Application Mod2022/1164
Development Application DA2022/1164
Issues response/ addendum Statement of Environmental Effects/ Updated
clause 4.6 variation request – Height of buildings
Demolition and construction of a commercial building
34-35 South Steyne, Manly

RFI letter of 1st September 2022

Updated Clause 4.6 variation request – Height of buildings

Figure 2: Extract of Section D with breaching elements located above red line

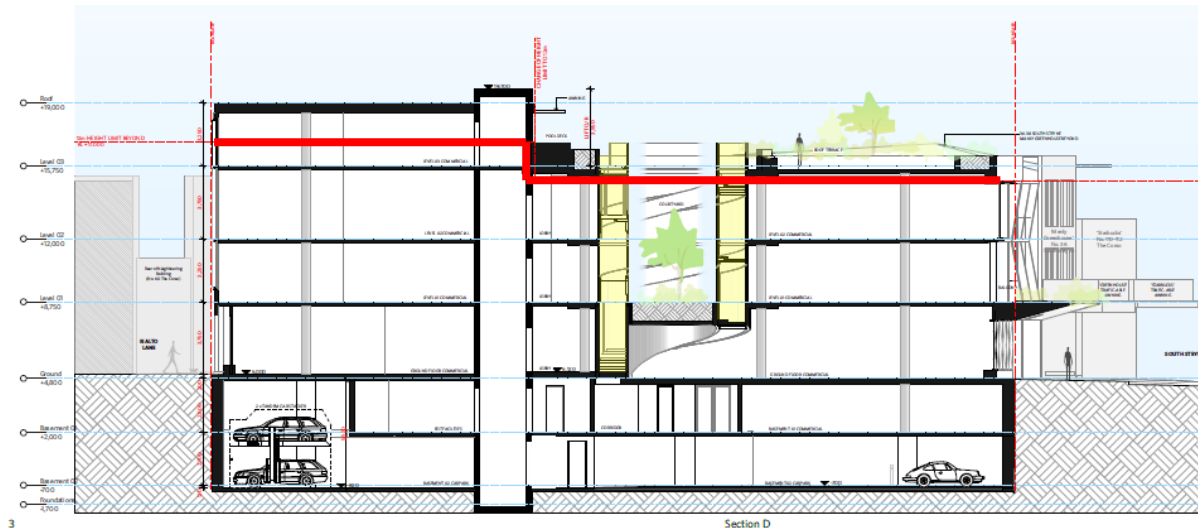
Within the portion of the site that is subject to the 10m height limit, the proposed development has a height of approximately 11.3m presenting to South Steyne, being the dominant parapet height and the height of all proposed roof top planters. The balustrade of the central staircase and the lap pool reach a maximum height of approximately 12m, with a small awning adjacent to the lift core reaching a maximum height of 13.6m.

Within the portion of the site that is subject to the 12m height limit, the proposed development has a height of approximately 14m presenting to Rialto Lane, reaching a maximum height of 14.5m at the lift core.

- Dominant parapet height = 11.3m, 1.3m or 13% variation to 10m height limit
- Central staircase and lap pool = 12.0m, 2.0m or 20% variation to 10m height limit
- Small awning adjacent to lift = 13.6m, 3.6m or 36% variation to 10m height limit

- Level 4 commercial area = 14m, 2m variation of 16.7% variation to 12m height limit
- Lift Overrun = 14.5m, 2.5m or 20.8% variation to 12m height limit

The extent of non-compliance is highlighted in red in the extract of Section D in Figure 2, over the page.

Figure 3: South Steyne Elevation

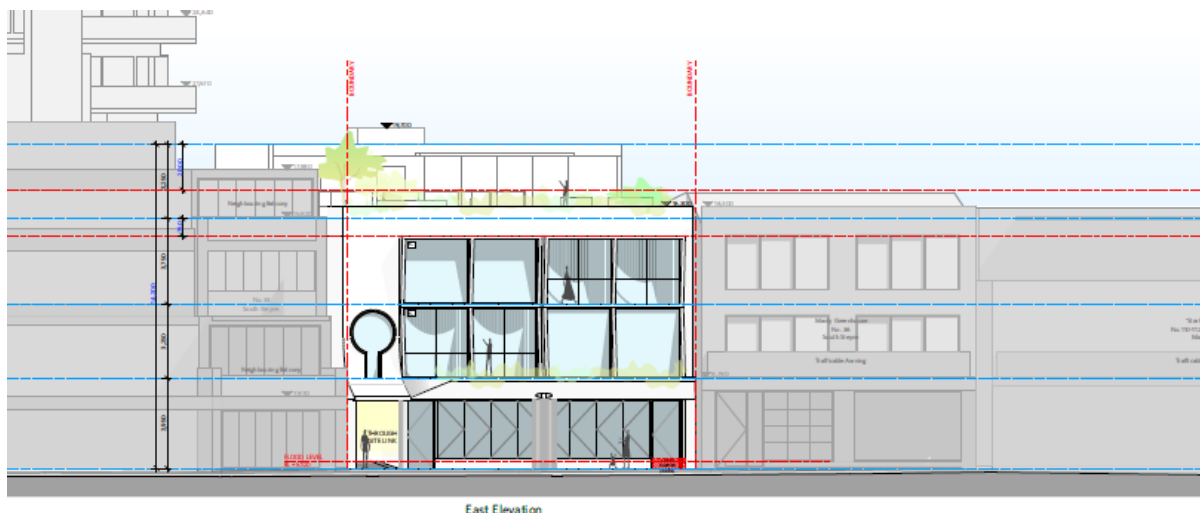
Comment: The height of the proposed development is consistent with that of surrounding development and development within the visual catchment of the site. In particular, the front parapet height of the development has been designed to marry with the height of adjoining buildings, as shown in Figure 3 over the page.

Figure 5: Rialto Lane Elevation

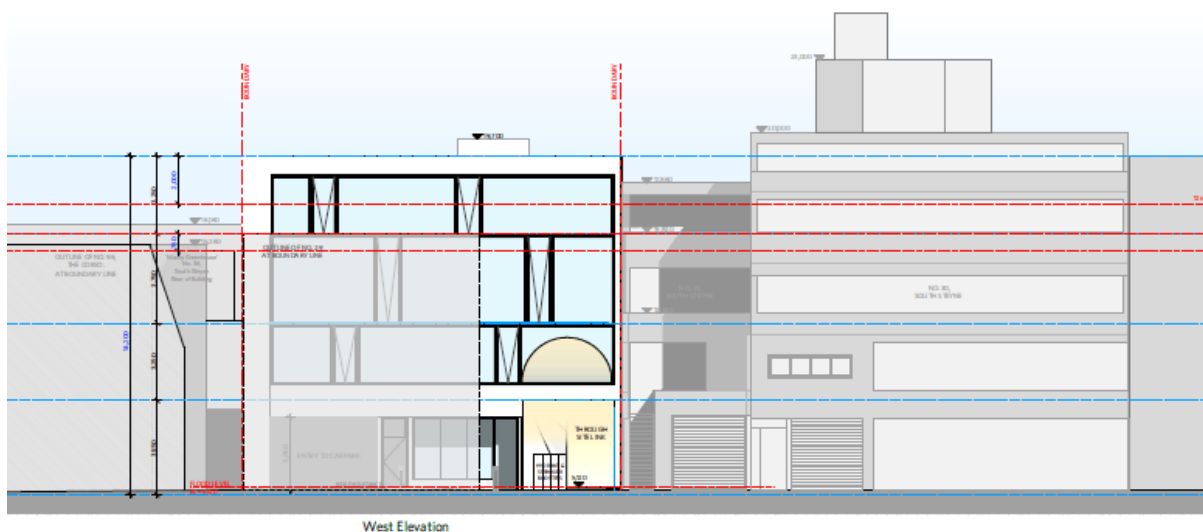
The increased height at the rear of the development is set back from the primary street frontage and will not be readily visible as seen from South Steyne. The height of the building presenting to Rialto Lane is contextually appropriate, having regard to the increased height anticipated by MLEP 2013 and the height of surrounding and nearby development, as shown in Figure 5 over the page.
